NOTICE OF DENIAL

RE: Application Number 23-8396; 2405 Burns St.; Indian Village Historic District

CERTIFICATE OF APPROPRIATENESS

RE: Application Number 23-8396; 2405 Burns St.; Indian Village Historic District

EAST ELEVATION

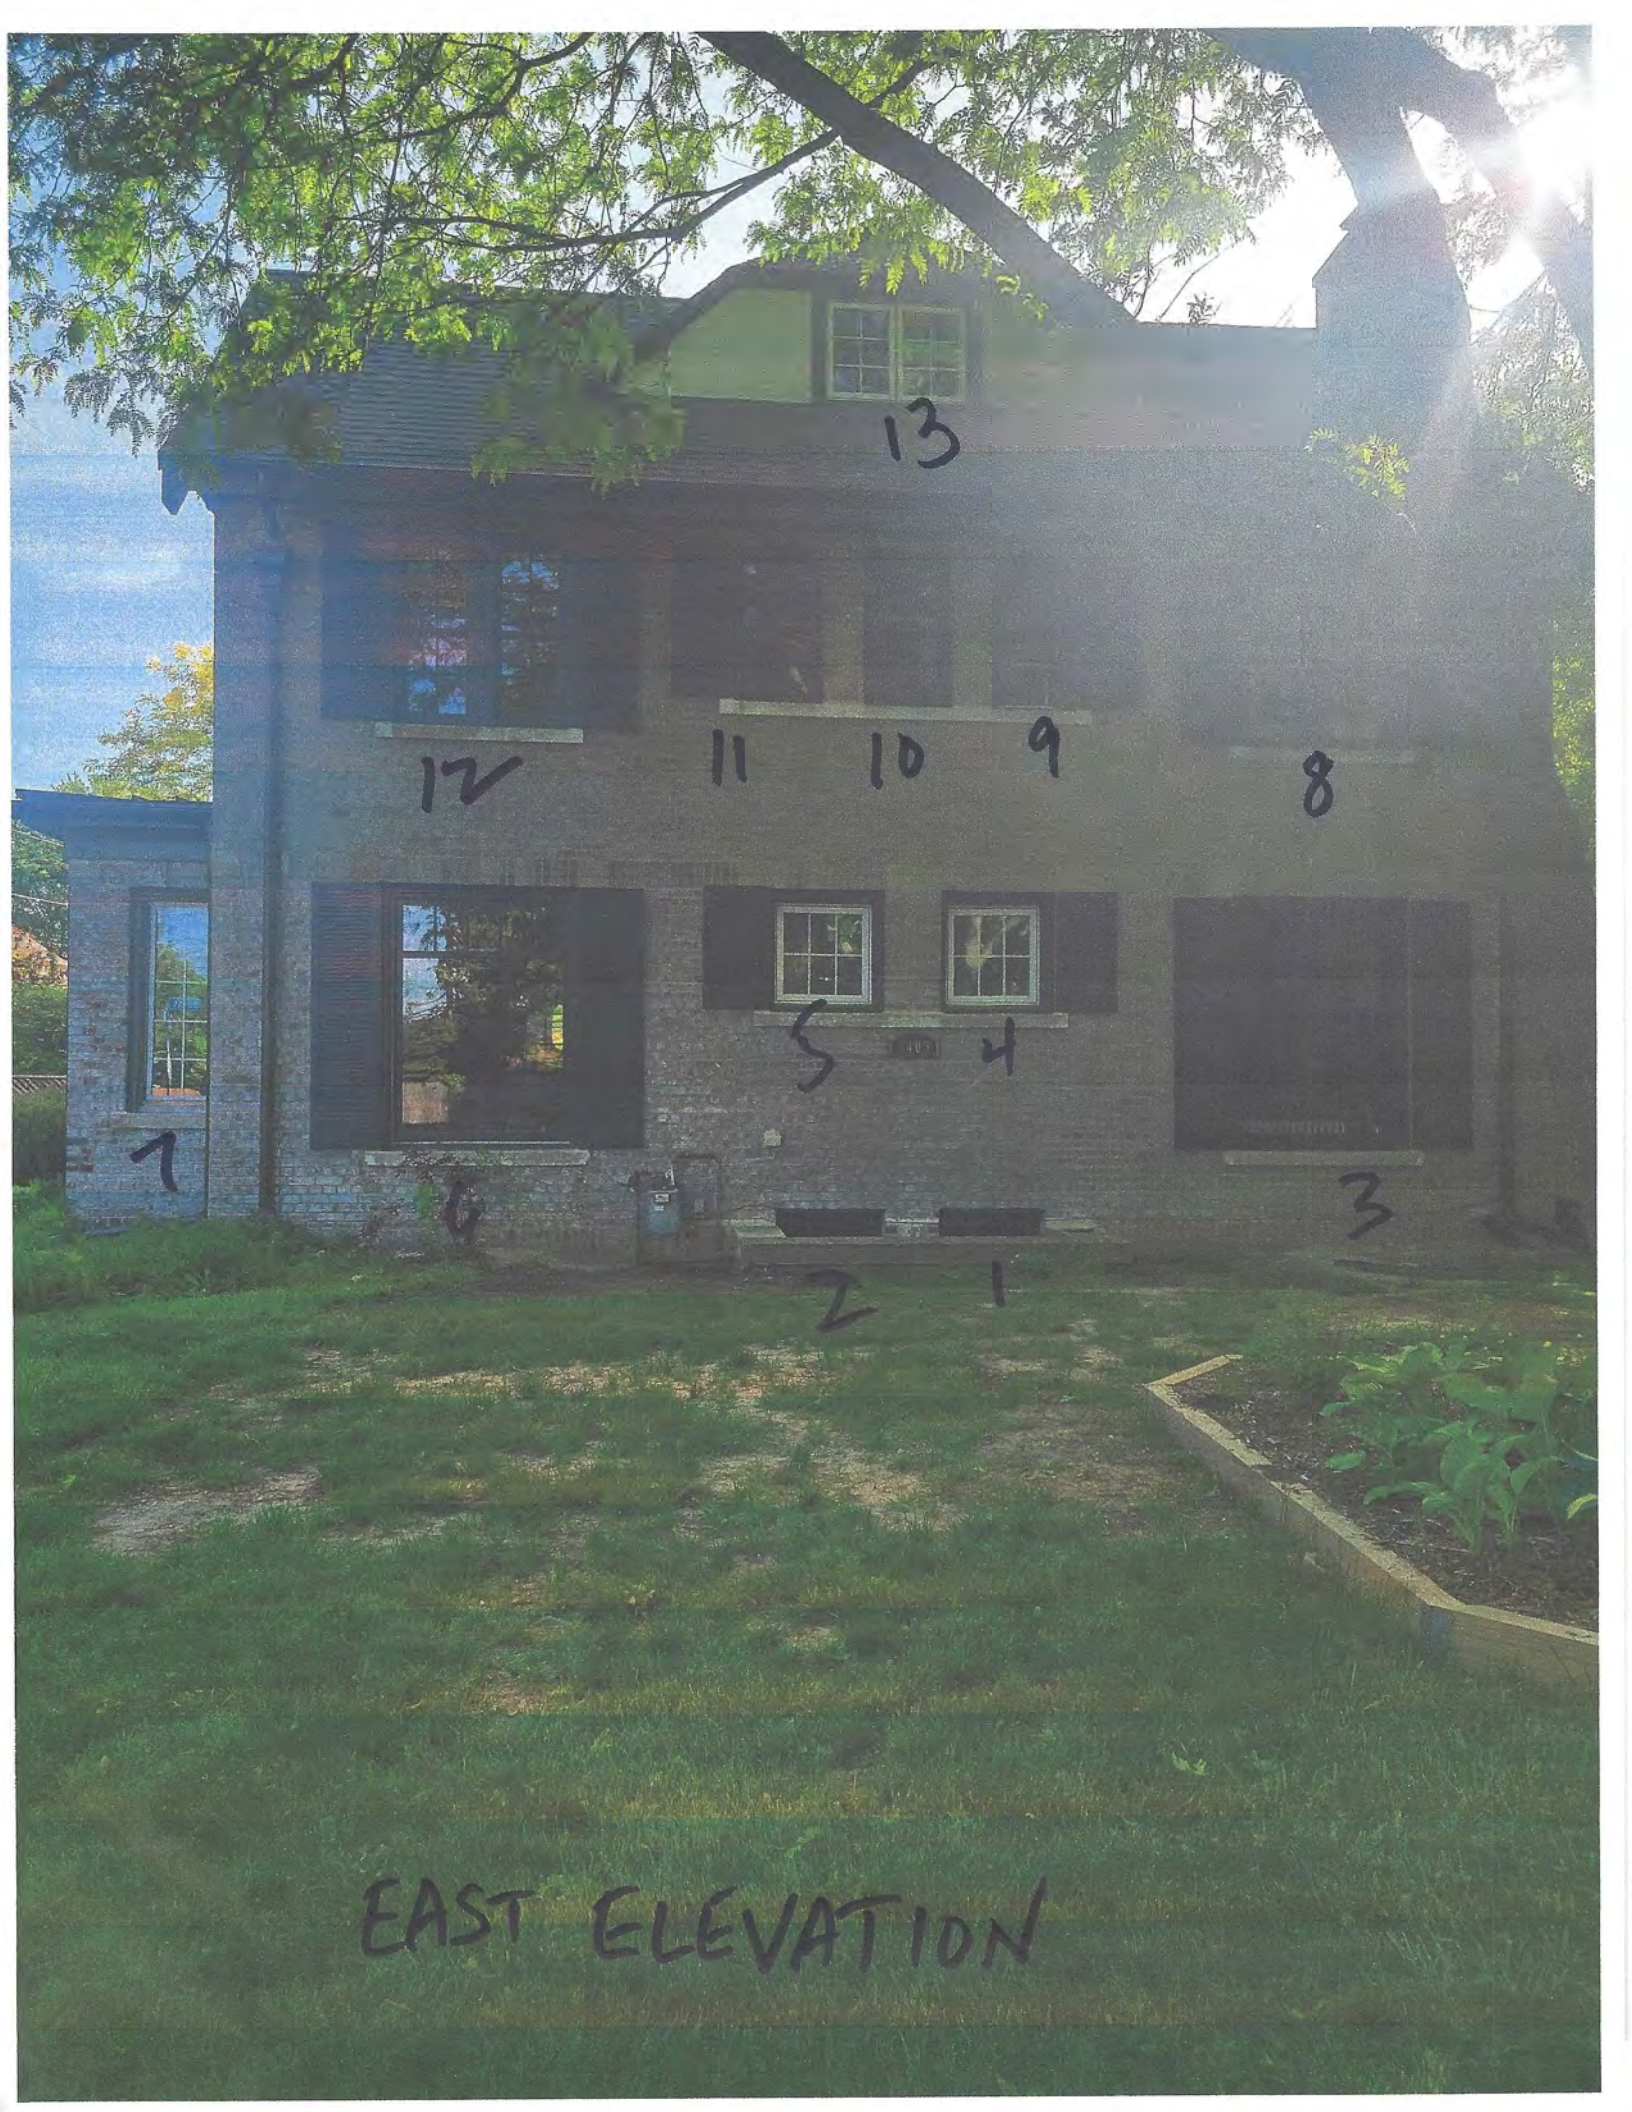
Window Renovation – East Elevation (one photo):

1,2 – basement, full size sash window pair. Found buried and intact. Removed, stripped, repaired and placed back into original openings.

3,6 – found in garage, stripped, repaired, reglazed. Replaced vinyl windows that was broken. Old replacement removed along with all breakmetal surrounding. Trim on outside cleaned and painted, inside frame from original installation still intact. Replaced brass insulating strips with identical new. Reglazed and stripped old window left in attic and rebuilt and reinstalled.

4,5 – replaced Vinyl window with windows from attic. **Windows are wood framed and 6 individual pains of glass. These were original windows from the attic.** Same process as previously explained. **Windows are operable.**

8-12 – **All are double hung, sash windows.** All are original windows that were removed from their frames, stripped and reglazed. All working hardware was reconditioned. Only new materials used in any of the rebuilds is the rope for the counterweights. All tracks were restored. No new glass was used.

13 – attic window will not be replaced

7 – Original window is currently being disassembled and reconditioned. **No work is being done now.**

SOUTH ELEVATION

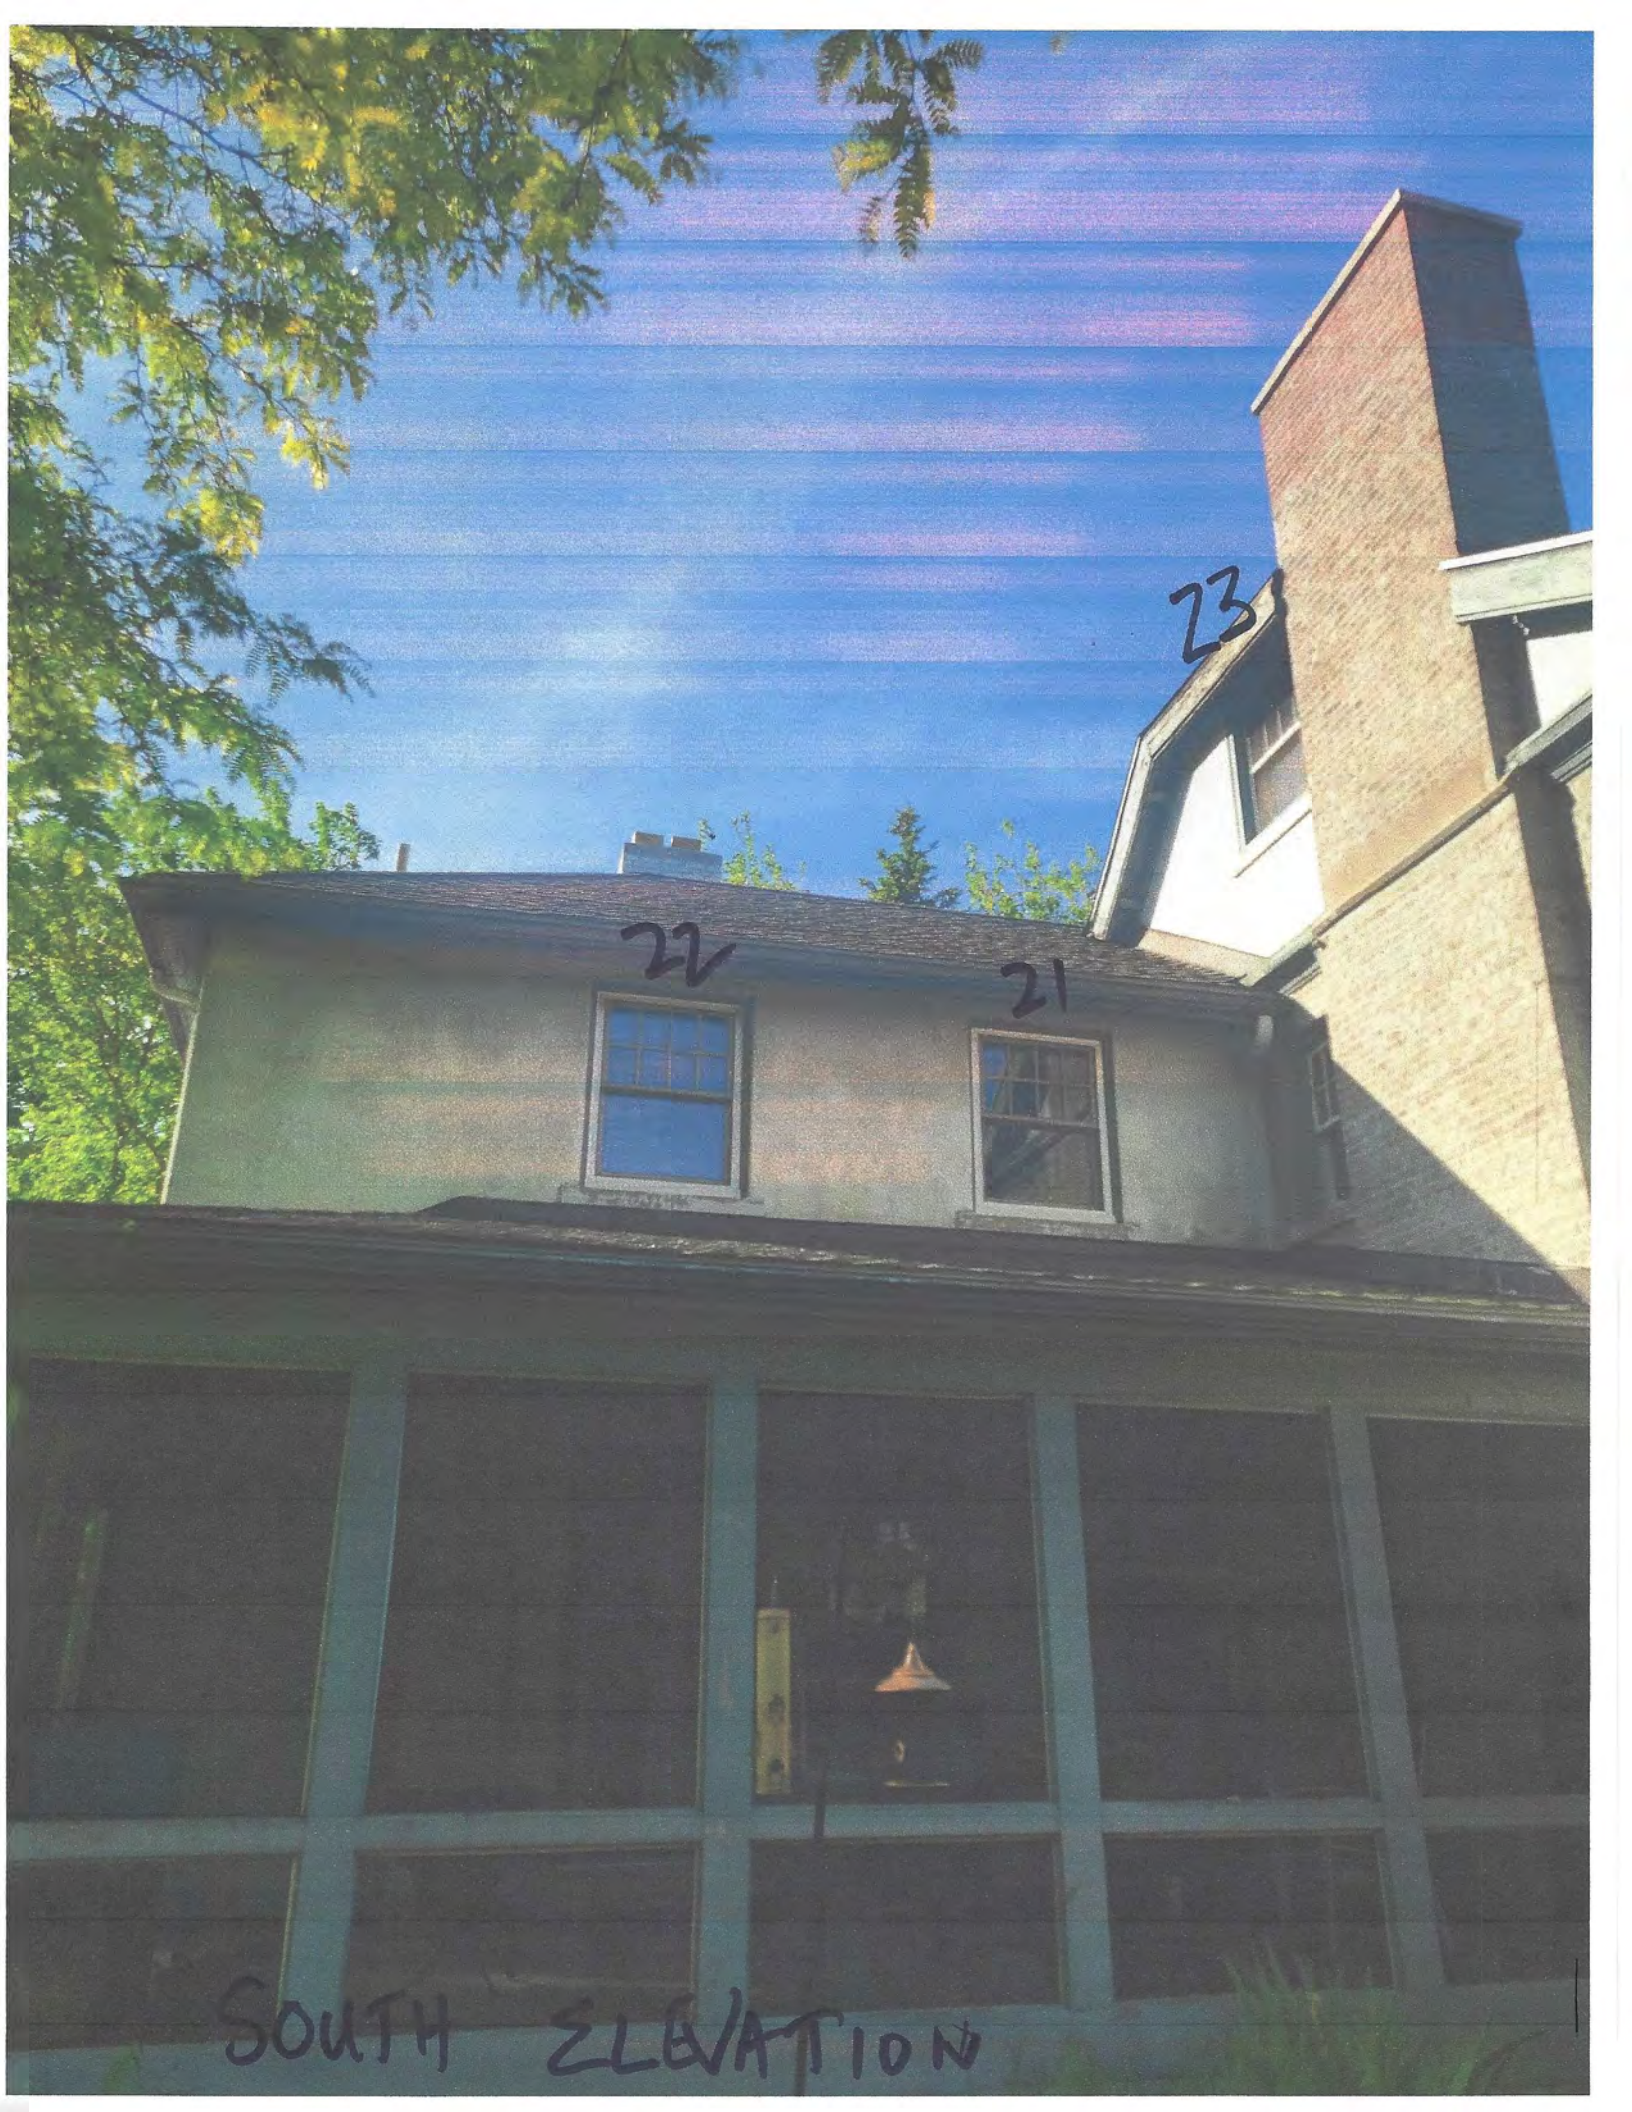
Window Renovation – South Elevation (3 photos):

14 – Vinyl windows to be replaced with found windows from attic **which are wood framed and the exact configuration as vinyl. The windows are double hung sash windows that are being reinstalled. The condition of the old windows is excellent.** Same window configuration as show in the vinyl window. Same process of stripping and repairing.

15 – Original windows that were still installed in opening. Windows were removed and cleaned, repaired and reglazed.

16 – windows found in attic and are being restored as previously described. **These windows are a combination of operable (one swings from left and one from right on brass hinges). Left to right are fixed, operable, fixed, operable, fixed. Hinge locations still on frames indicating the original configuration.**

17- original window restored.

SOUTH ELEVATION

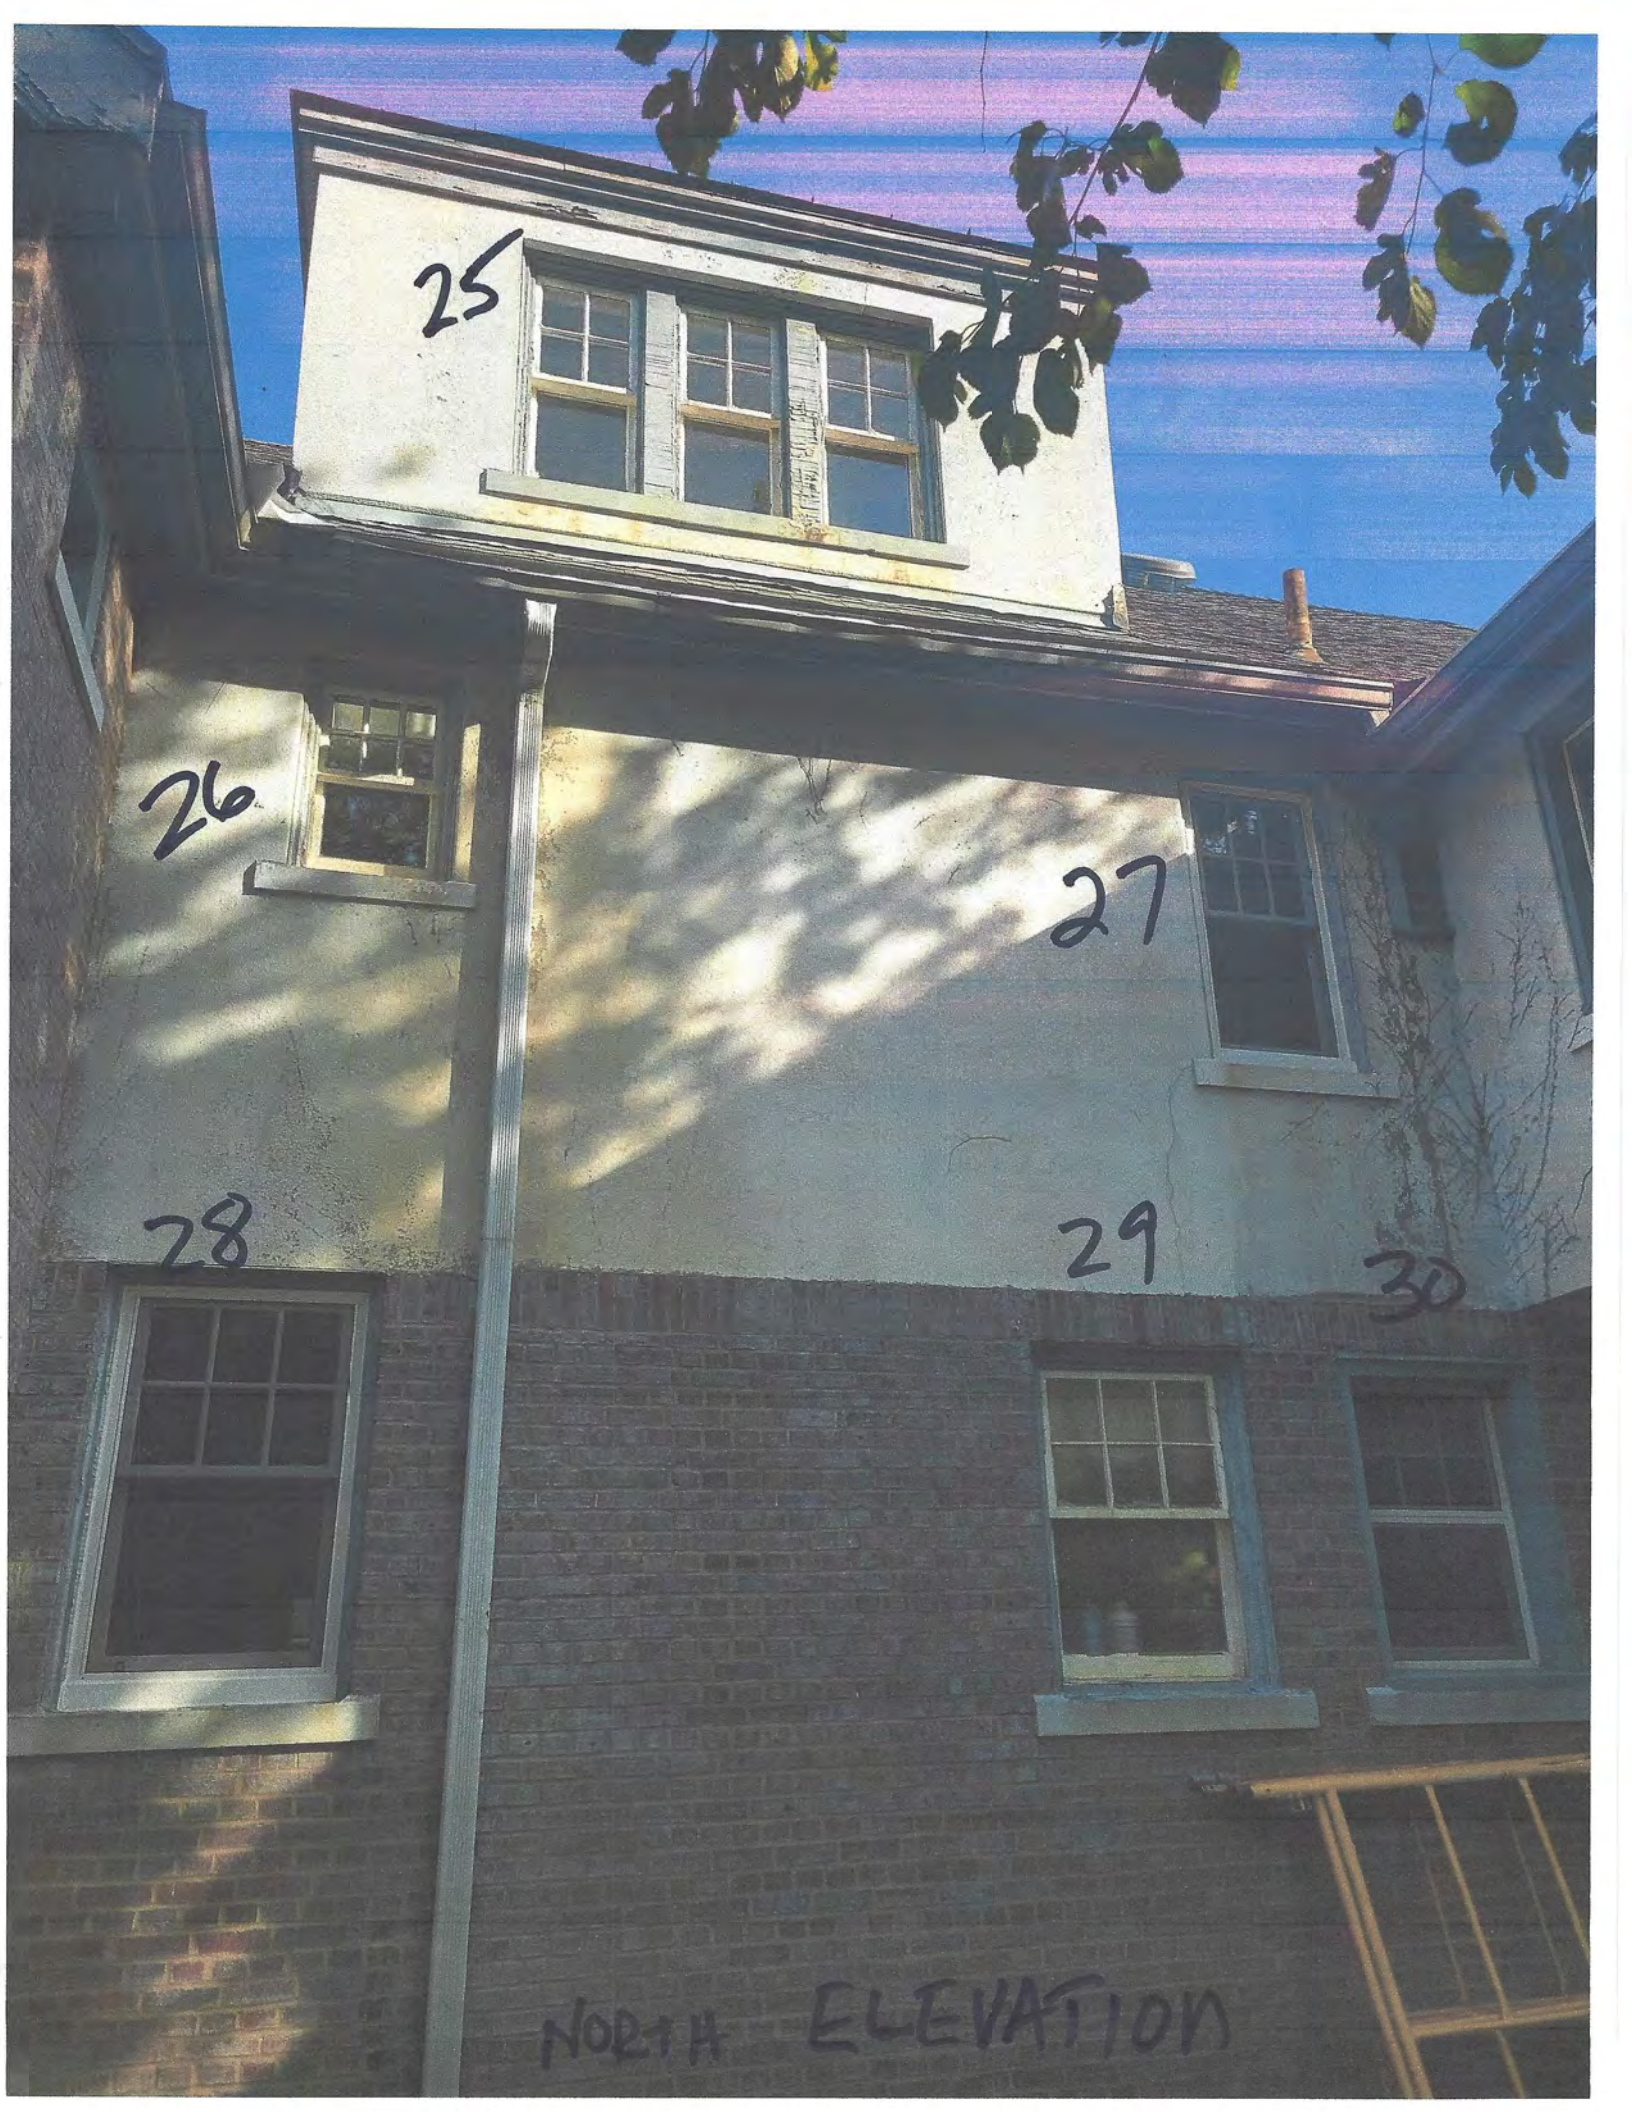
18 – 22 – currently showing the vinyl windows. Original windows to be installed after restoration.

23 – attic window vinyl, **not found in pile of old windows. I would like to have this window custom made to match the original windows in the house.**
